ADDRESS: 2517 Eastlake Ave E
Seattle, WA 98102

SDCI PROJECT NO: 3033787-EG

7.1 | OVERALL RENDERINGS 86

4.0 | EDG RESPONSE: ARCHITECTURAL CONCEPT

ALTERNATIVE 3
Preferred | Edge Events

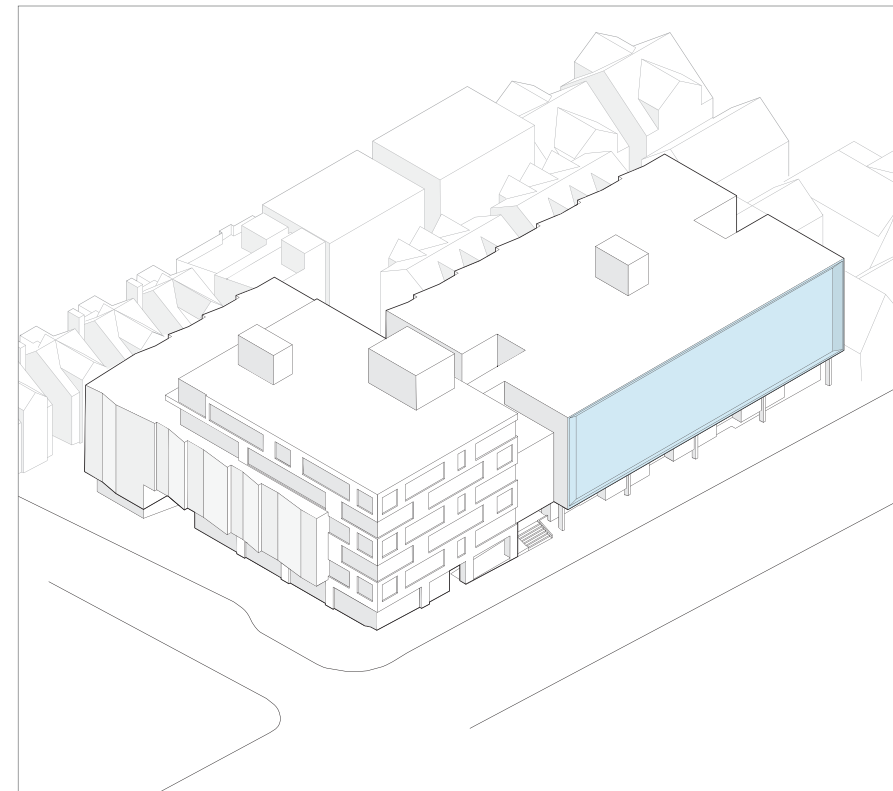
DESIGN REVIEW BOARD DIRECTION:
3a. The Board expressed general support for the design concept of smaller identifiable forms coming together as an integrated whole but agreed that they did not yet see a clear relationship between pieces. (DC2-B)

+ The proposal maintains a concept of creating a composition of small identifiable forms. The intention is to balance the identity of the “parts” with shared materials, building elements and facade arrangements to create a collective whole. Each “Edge Event” is intended to be a response to its adjacent conditions as described at the Early Design Guidance meeting. The corner Anchor, Park View Frame, Residential Bays and Arbor-way Edge all remain as separate elements in order to reduce the scale, bulk and to be compatible with its surroundings. For the project to have a clear relationship between the pieces the project considered:

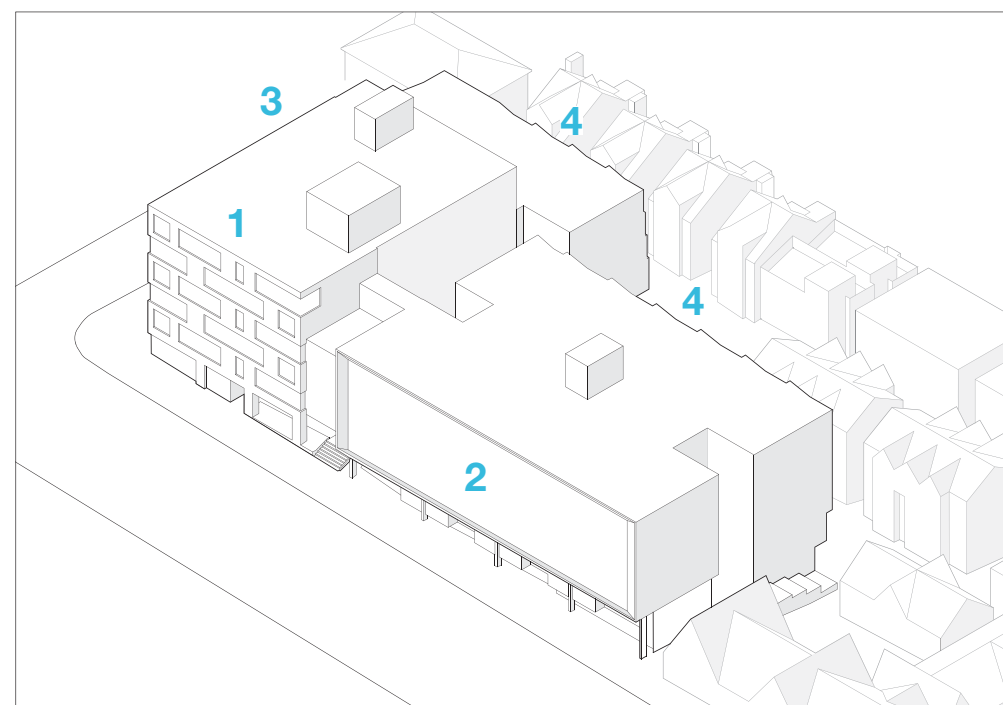
DESIGN REVIEW BOARD DIRECTION:
 1a. The Board supported Option C and agreed that the idea of smaller forms combined in a larger whole could be an effective strategy for breaking down the scale of this large project. (CS2-D)

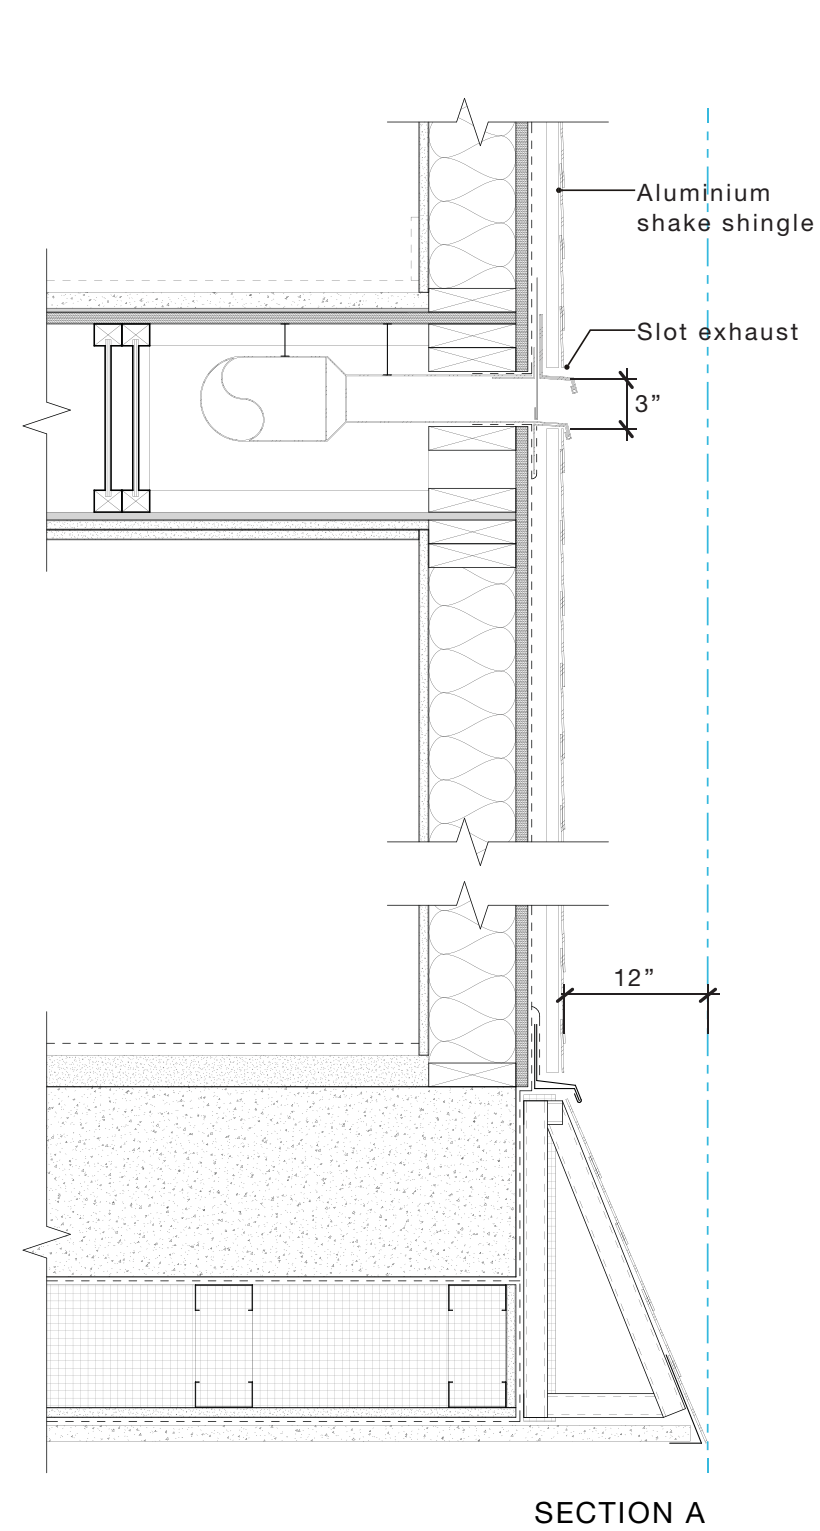
DESIGN REVIEW BOARD DIRECTION:
 4g. The Board supported the schematic thinking behind Park View Frame concept, making particular reference to the precedents provided in the packet. The Board agreed that the success of this scheme would depend on making a meaningful connection between the residential units and Rogers Park and encouraged the design team to develop this edge with a high percentage of glazing and occupiable exterior space in deep recesses. (DC2, PL1)

- Variety of flush and Juliette balconies to promote a residential presence.
- 12" deep angled / flair of aluminum shake shingle cladding to reflect qualities of the park across the street
- 3" wide exhaust slots to minimize the presence of mechanical elements on the facade.

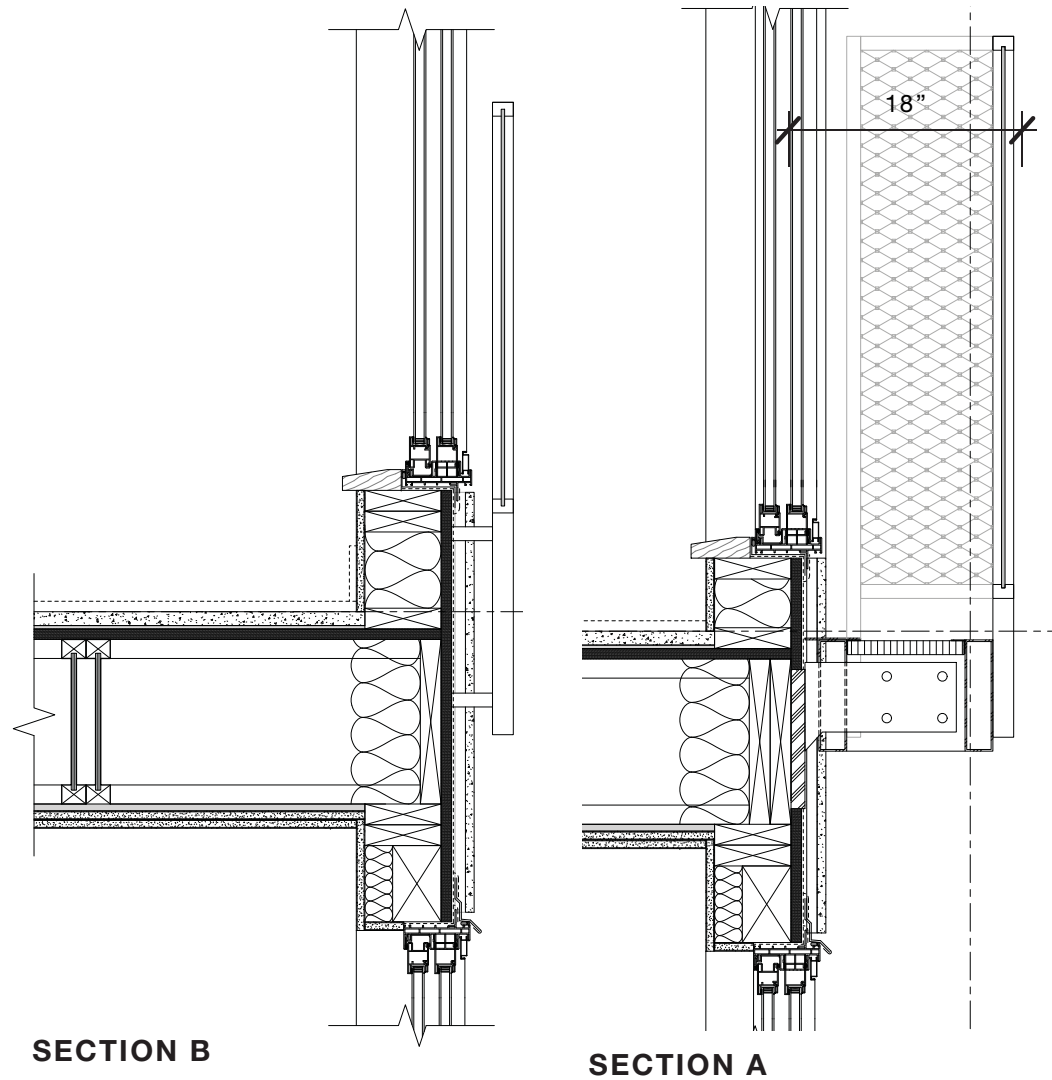
DESIGN REVIEW BOARD DIRECTION:
 4g. The Board supported the schematic thinking behind Park View Frame concept, making particular reference to the precedents provided in the packet. The Board agreed that the success of this scheme would depend on making a meaningful connection between the residential units and Rogers Park and encouraged the design team to develop this edge with a high percentage of glazing and occupiable exterior space in deep recesses. (DC2, PL1)

+ To the left is a detail of the proposed flush and Juliette balconies on the Park View Frame. The in-fill panels are proposed as cable-mesh to suggest some of the aspirational qualities of the neighborhood adjacent to the lake. (Please see p. 23 for additional information)

EDG | 05.29.2019

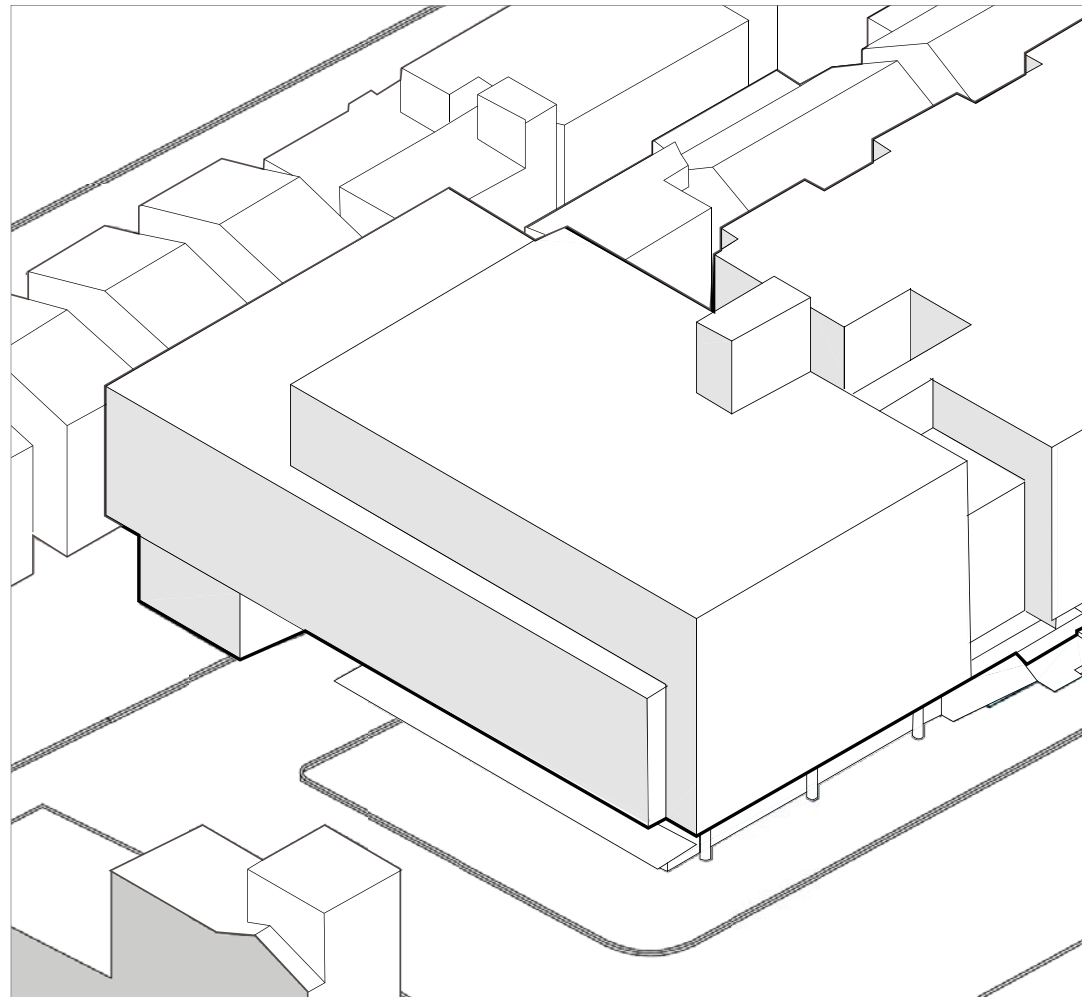
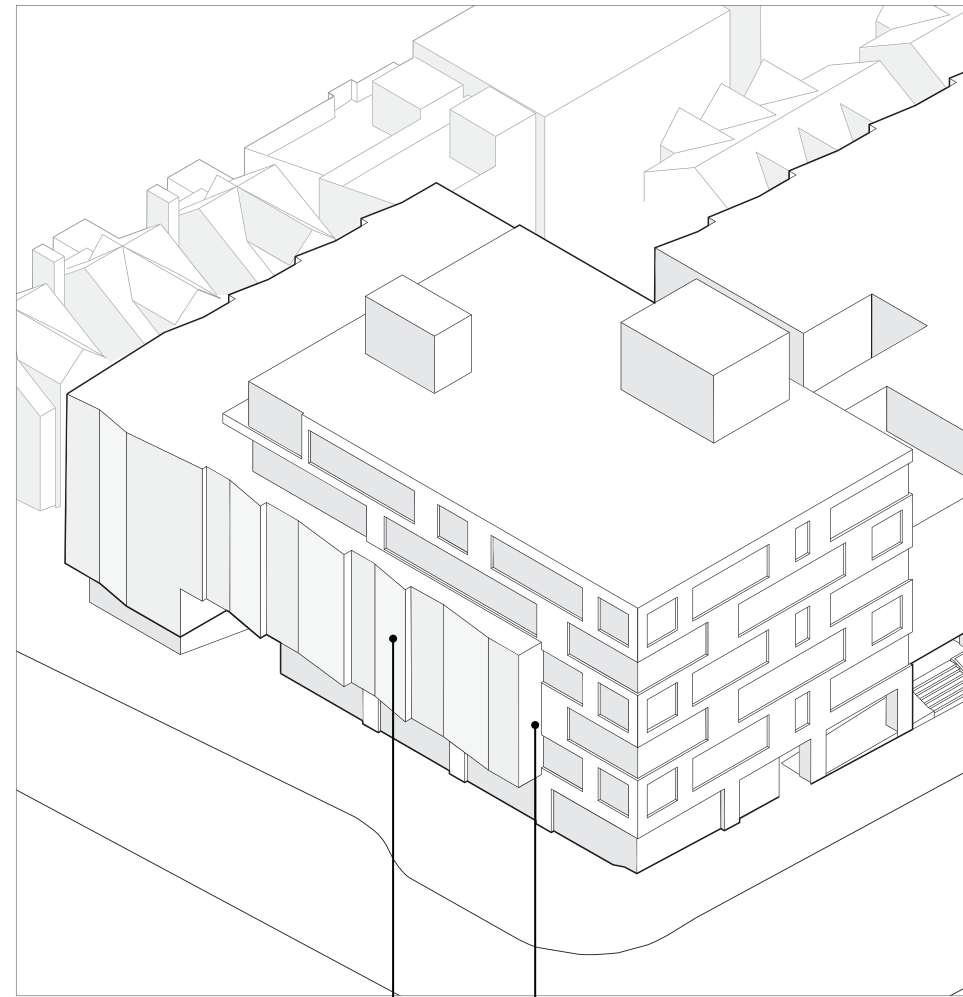
DESIGN REVIEW BOARD DIRECTION:
5a. The Board did not support the massing proposed for this edge, agreeing that the large cantilevered mass of the upper levels did not seem to be an appropriate response to context. (CS2, DC2)

Horizontal bar reduced in length

EDG L03 PLAN

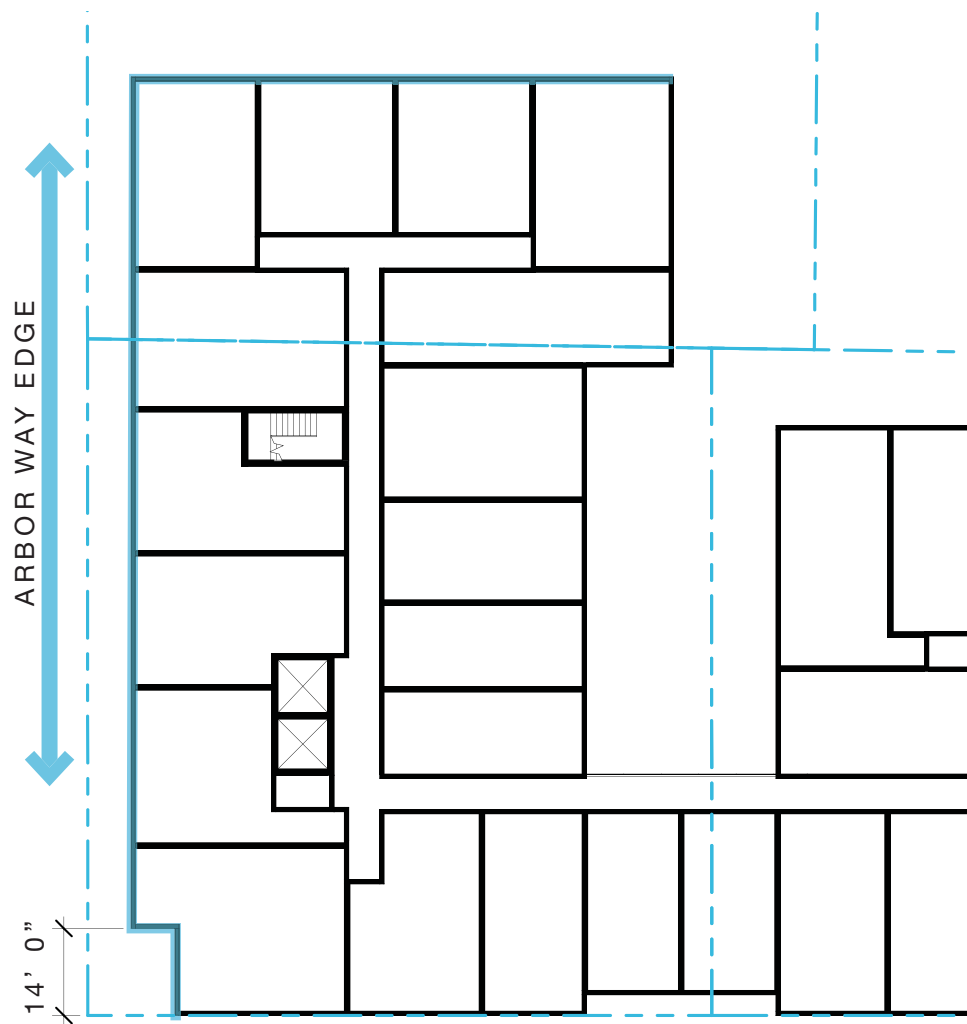
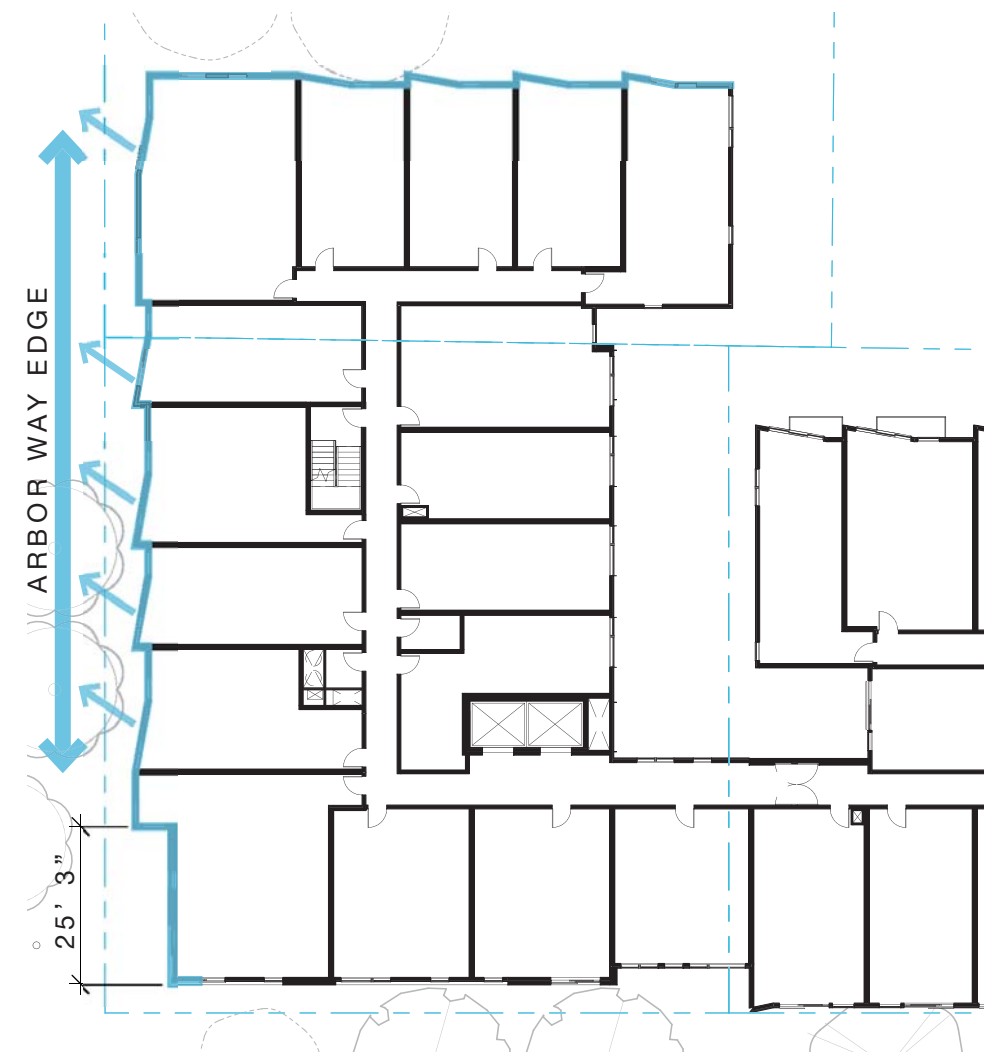
DESIGN REVIEW BOARD DIRECTION:
 5a. The Board did not support the massing proposed for this edge, agreeing that the large cantilevered mass of the upper levels did not seem to be an appropriate response to context. (CS2, DC2)

- + The comparative plan diagrams to the left between the EDG and the Recommendation proposal show proposed inflected bays on the south facade angling toward the arbor way pedestrian path, and away from the neighbors to the west on the west facade. These bays are intended to add a residential presence to the pedestrian experience along the arbor way.
- + The “inflected bays” wrap the southwest corner to angle away from the neighbors to the west and add modulation of a smaller “grain” to the facade.

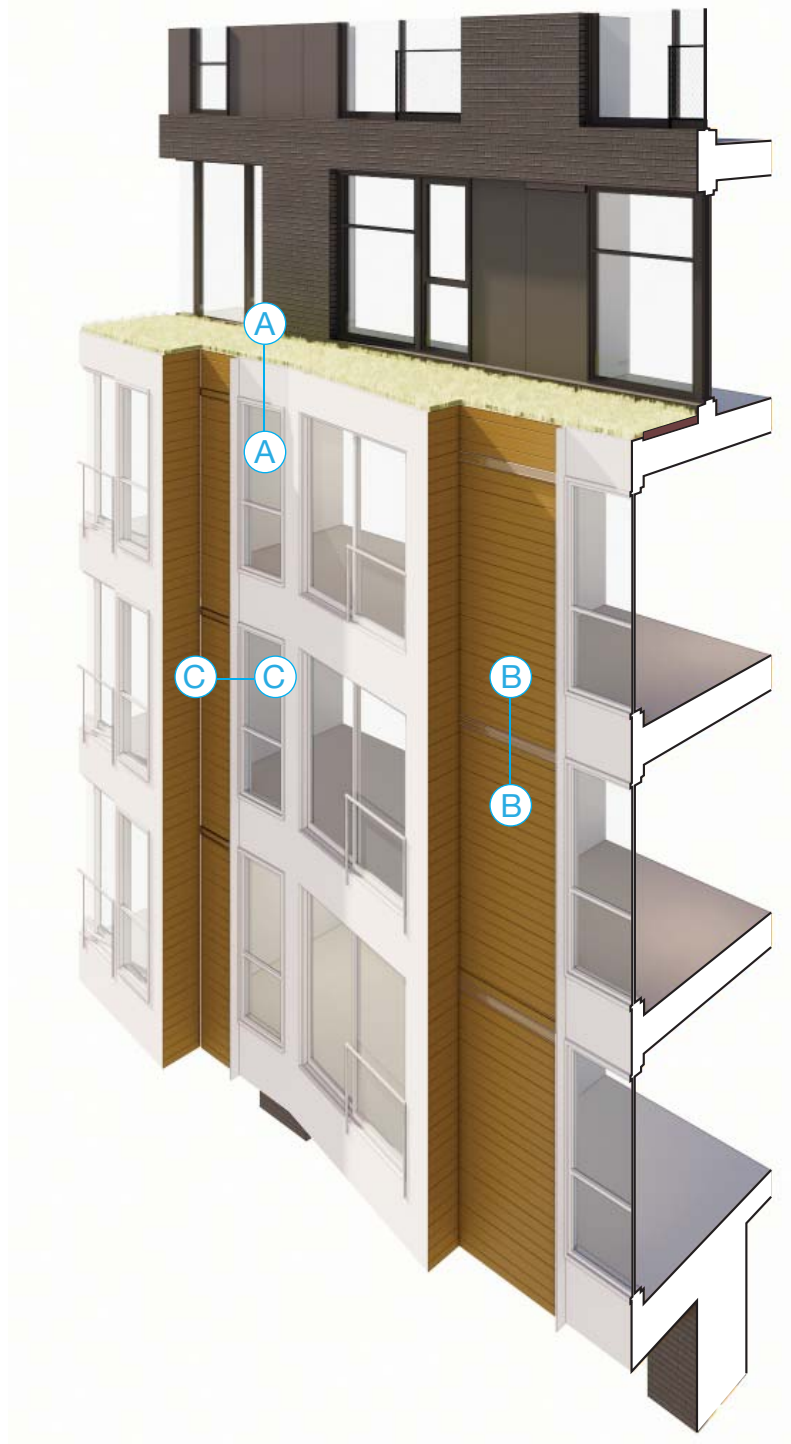
3c. The Board noted several unsuccessful nearby projects with similar compositional approaches and agreed that a simple composition of a few high-quality materials would likely be more effective. (DC2, CS3)

- + The exterior cladding of the arbor way is refined to express a residential character with a facade composed of angular “inflected bay” window groupings. The angular quality of the bays are continued with the use of 5/8” thick lap siding to provide a horizontal texture to balance the vertical bays.
- + Concealed 3” slot exhaust vents are integrated with the horizontal lap siding.
- + The window groupings are accented with a vertical batten. The brick veneer, lap siding and battens suggest similar details found on the west section of the TOPS K-8 school.
